**REPORT OF THE
OPERATIONAL SAFETY REVIEW TEAM
(OSART)
MISSION
TO THE
CHINON
NUCLEAR POWER PLANT
FRANCE**

27 NOVEMBER TO 14 DECEMBER 2007

FOLLOW-UP VISIT

**OPERATIONAL SAFETY REVIEW TEAM MISSION
IAEA-NSNI/OSART/09/144F**

ILLUSTRATION:

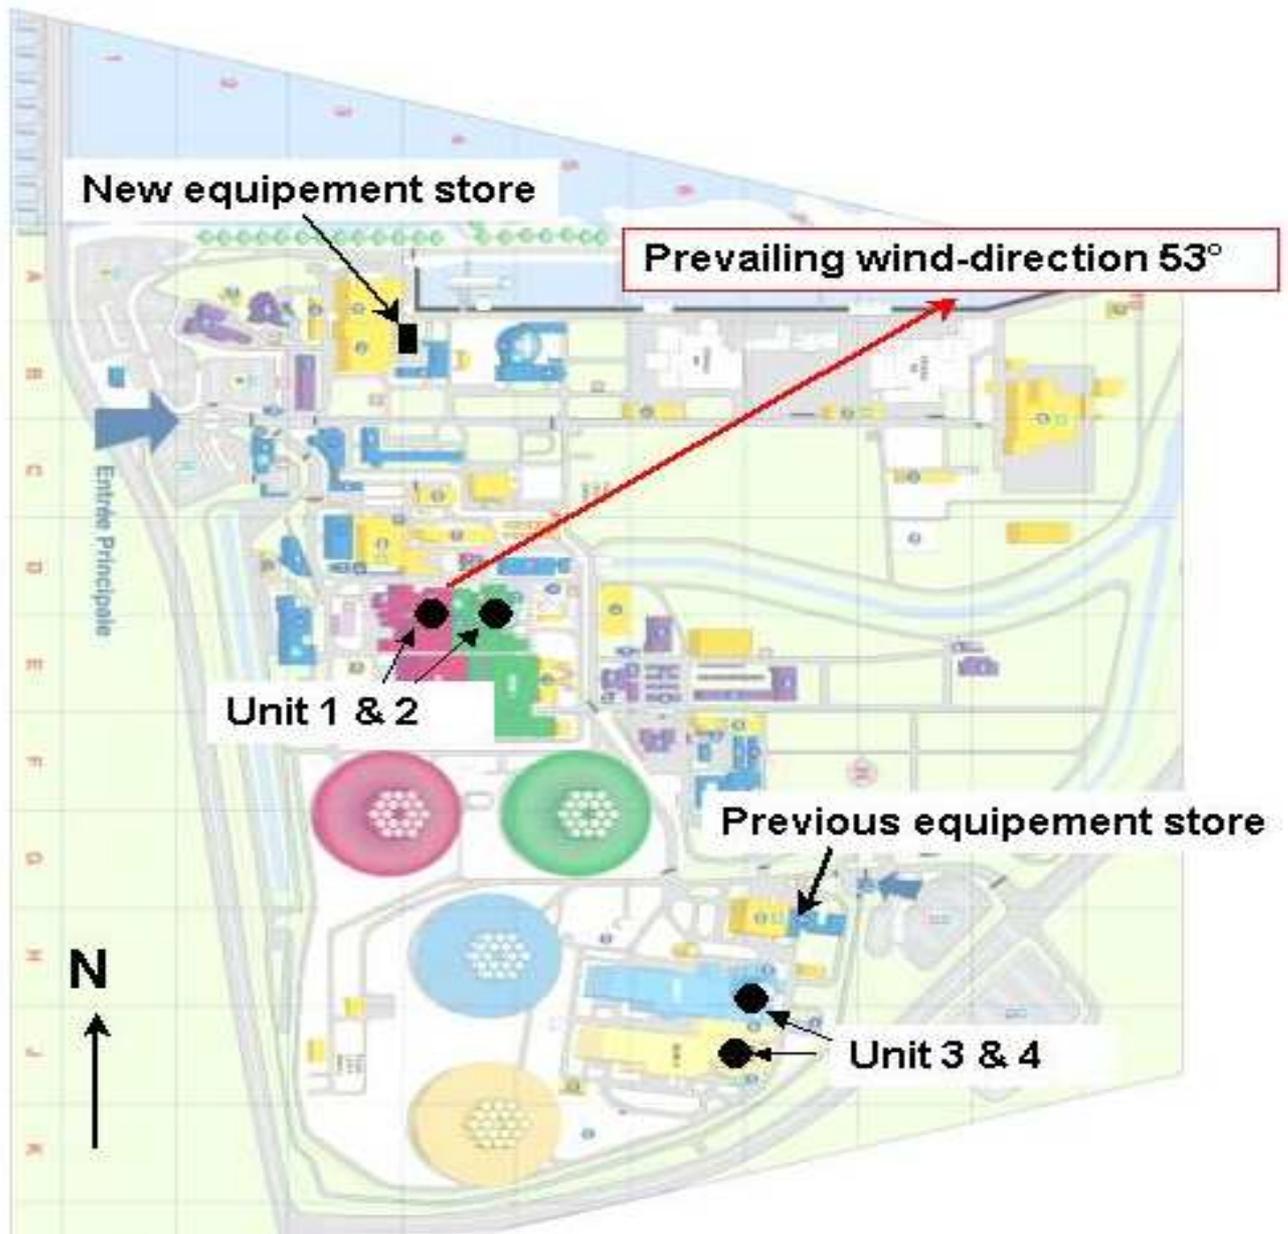
The following illustration shows the new location of the equipment with regards to the prevailing winds:

Since this relocation has taken place, one EPP drill has been performed with the equipment of the casualty treatment and sorting centre, and its results were satisfactory.
